## ORIGINATION FORM

Proposed Revisions to a Standard Plans Index  
(Please provide all information — Incomplete forms will be returned)

Index Number: 425-060  
Sheet Number (s): 3 and 4 of 4  
Index Title: Back of Sidewalk Drainage

SHEET  
3 of 4

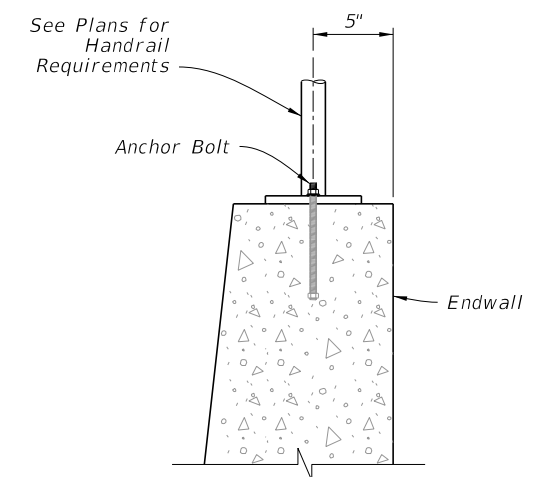
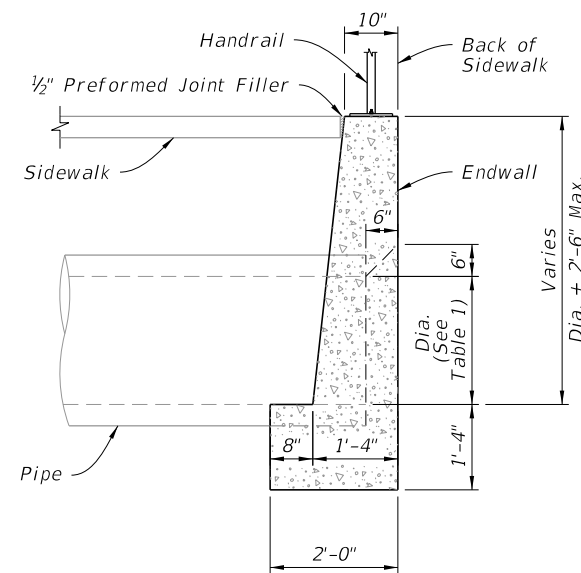
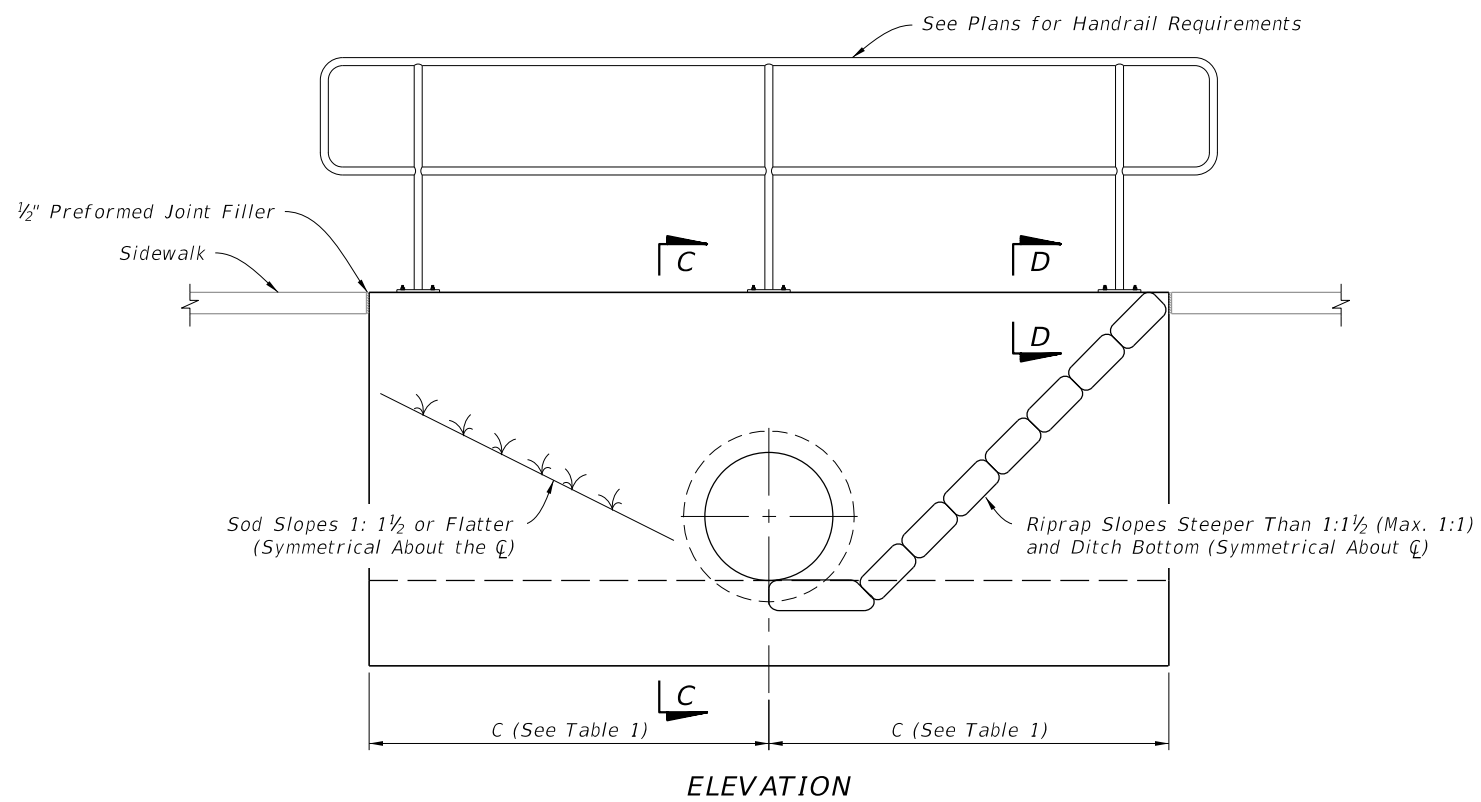
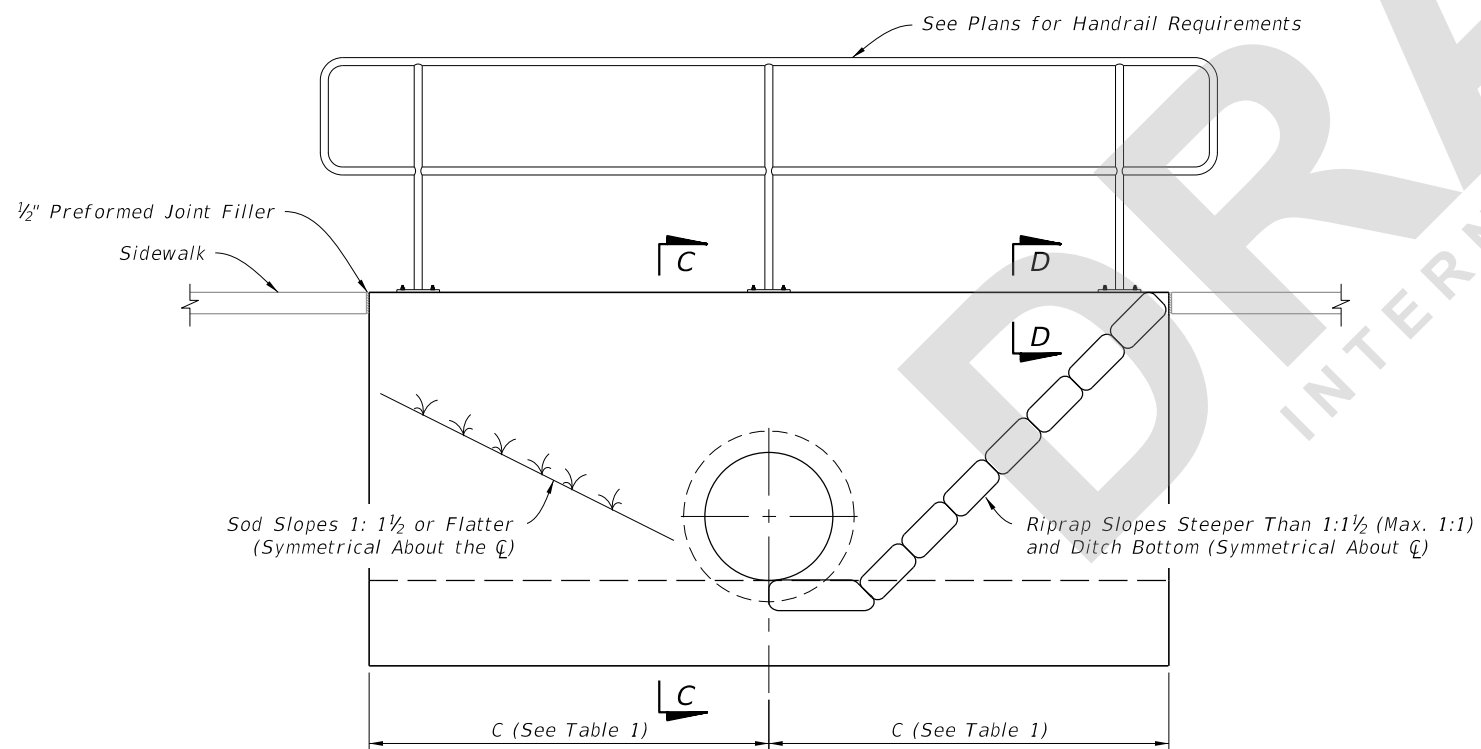
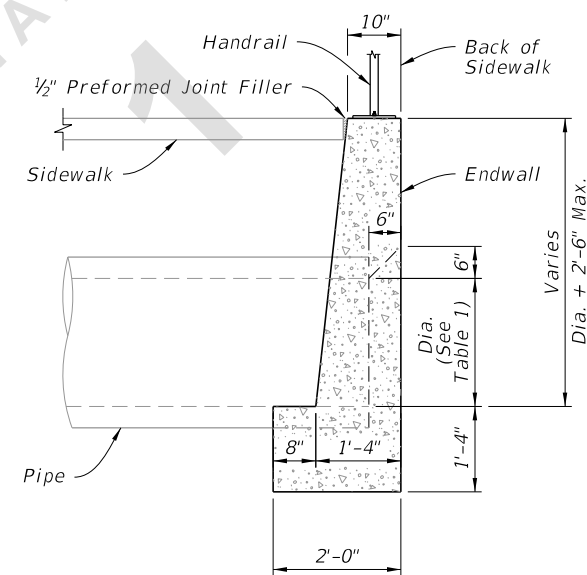
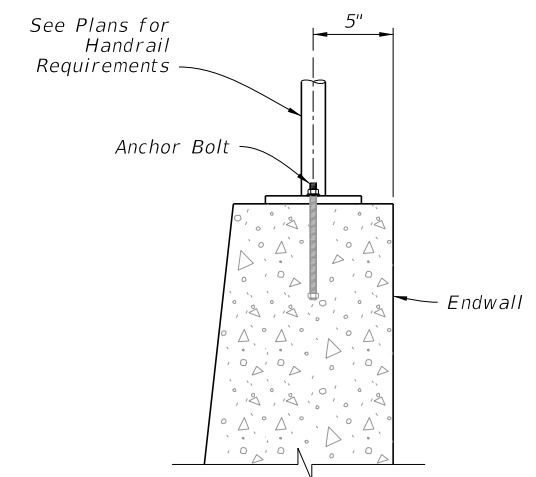
Sheet 3: Changed "Class I" to "Class II" in Table 1.

CHANGED TO: Class II

**SHALLOW DITCHES**

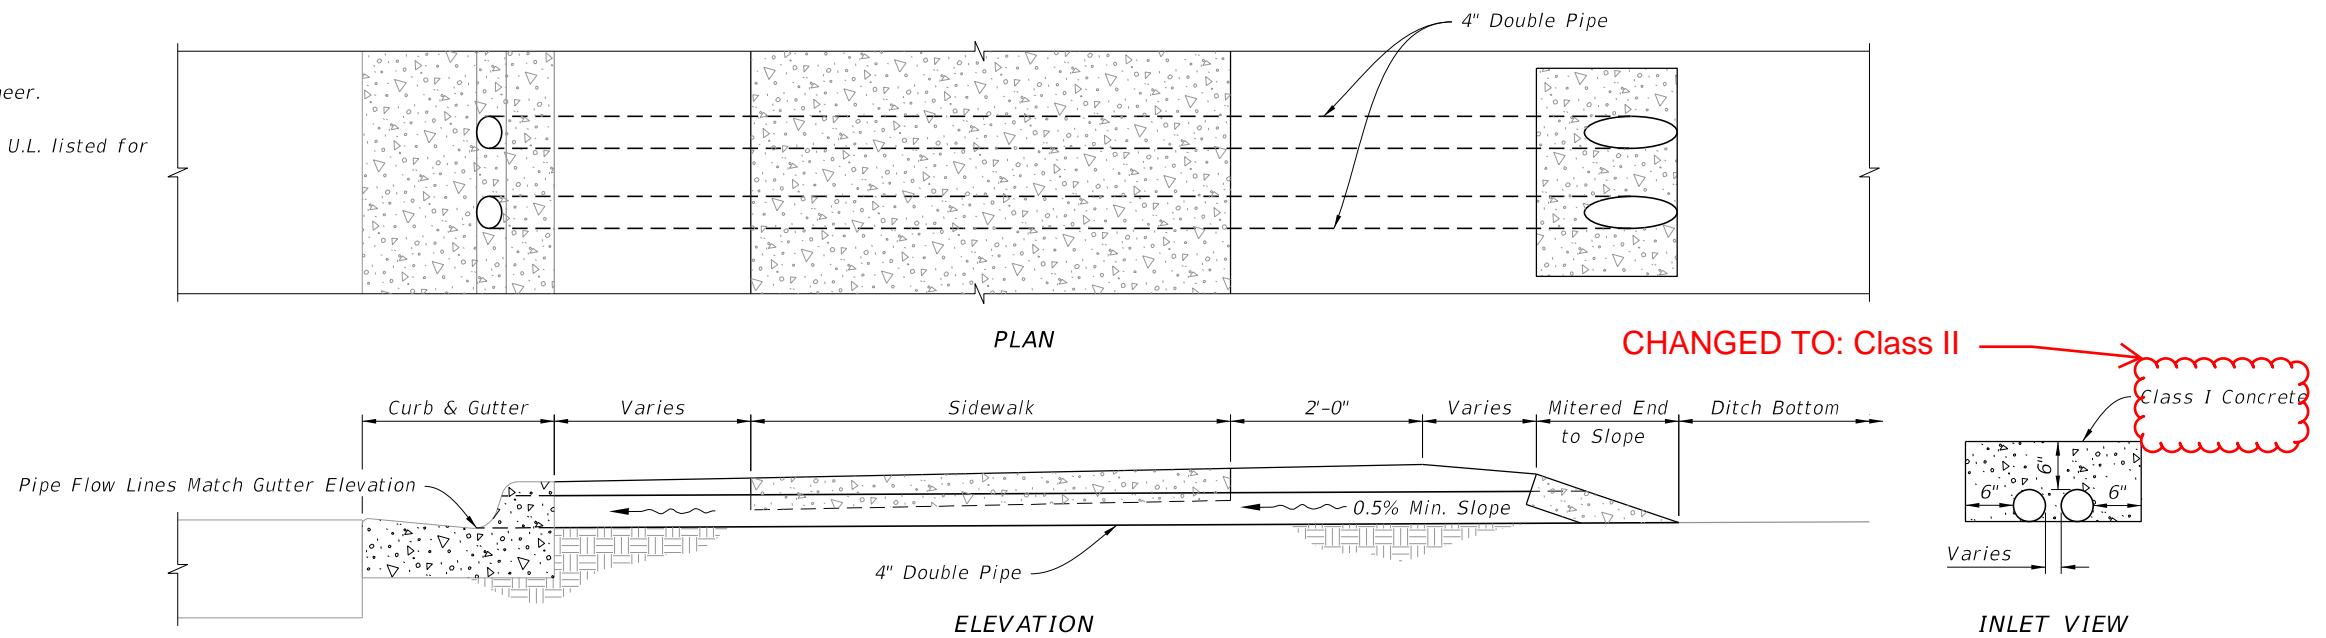
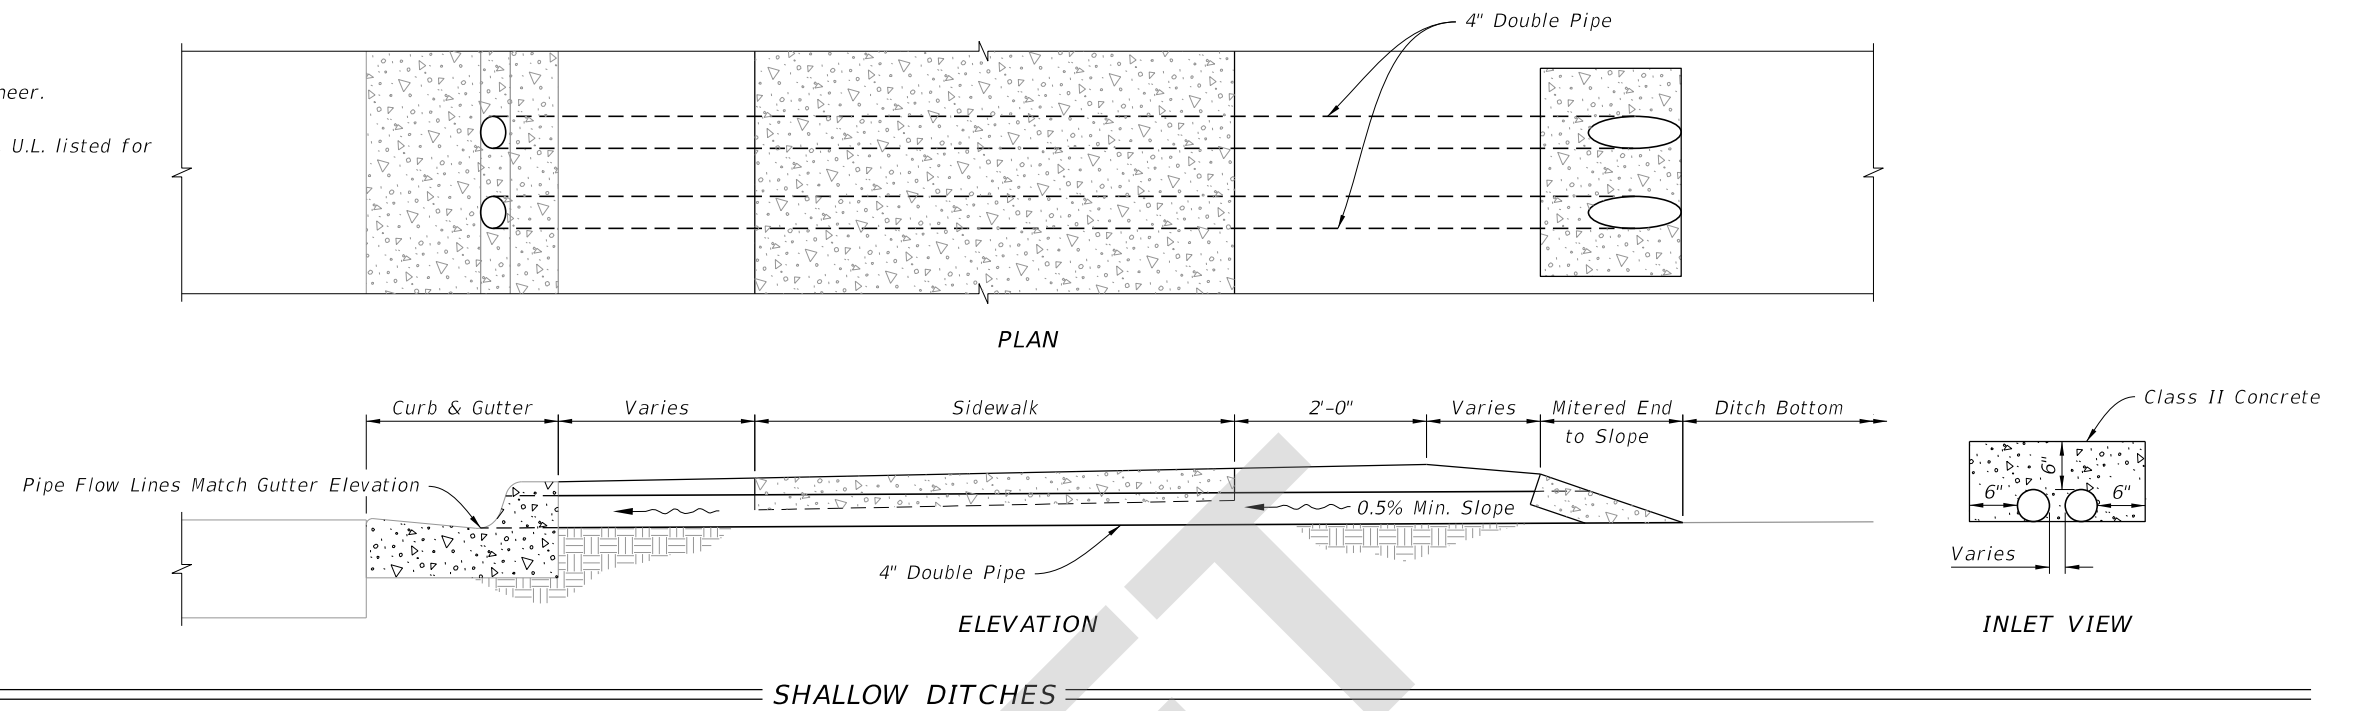
Sheet 4: : Changed "Class I" to "Class II" in the SHALLOW DITCHES - INLET VIEW detail.
